PROPOSED TECHNICAL SPECIFICATION

BROWNS FERRY NUCLEAR PLANT

UNIT 2

(TVA BFN TS 285)

APRM Flow Reference Scram and APRM Rod Block Settings
Fig. 2.1-1

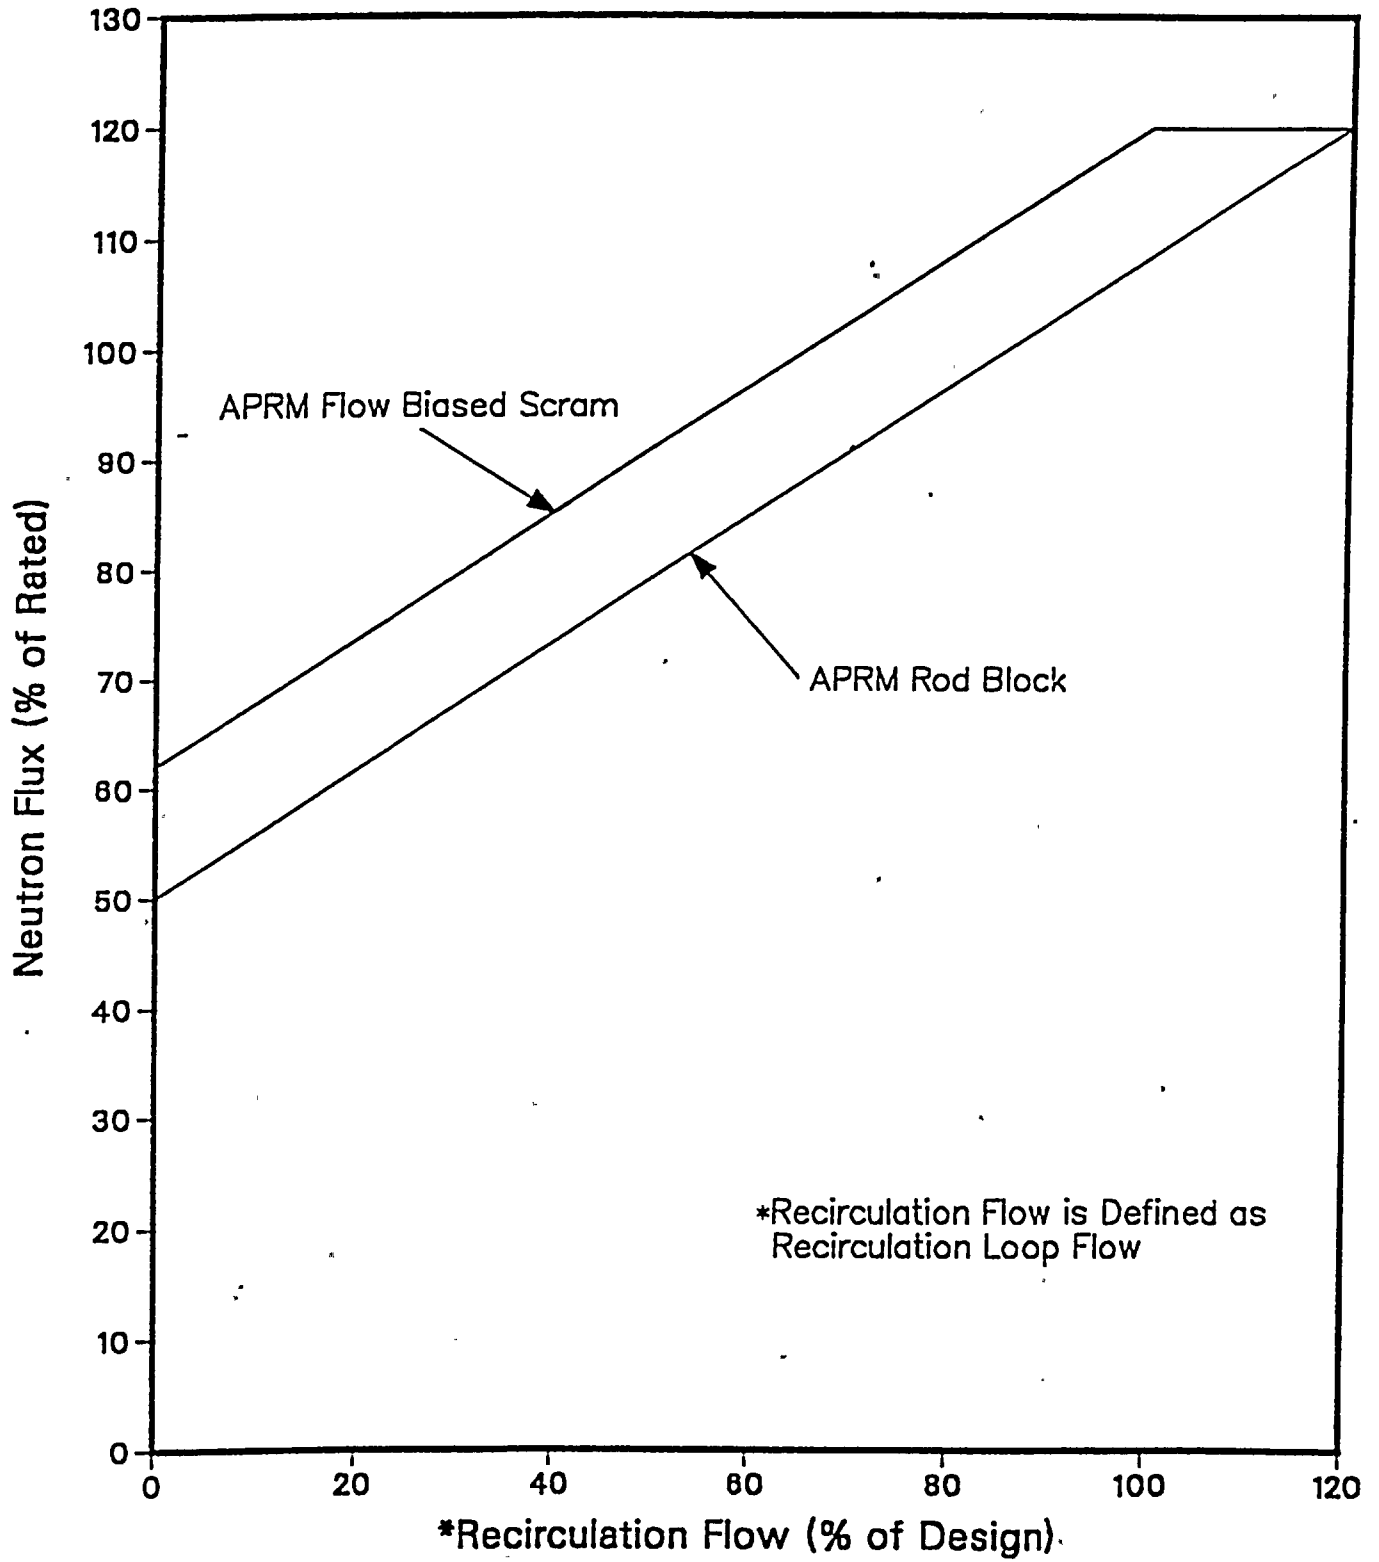
2. Replace Figures 2.1-1 and 2.1-2 with the enclosed revisions.

1. Limiting Safety System Settings (LSSS) 2.1.A.1.a and 2.1.A.1.c are being revised to specify new equations for the flow-biased APRM scram and rod block setpoints.
2. Figures 2.1-1 and 2.1-2 are being changed to show the revised flow-biased scram and rod block lines.
3. The Bases Section 2.1 is being revised to include the increased power/flow domain for which it is applicable, to reference the supporting licensing report, to correct typographical errors, and to make editorial changes in the text.
4. Table 3.2.C is being changed to show the revised APRM upscale trip level setting.
5. Limiting Condition for Operation (LCO) 3.5.L.1 is being revised to correct a typographical error and to specify new equations for the APRM flow-biased scram and rod block setpoints as modified by the ratio of fraction of rated power (FRP) to core maximum fraction of limiting power density (CMFLPD).
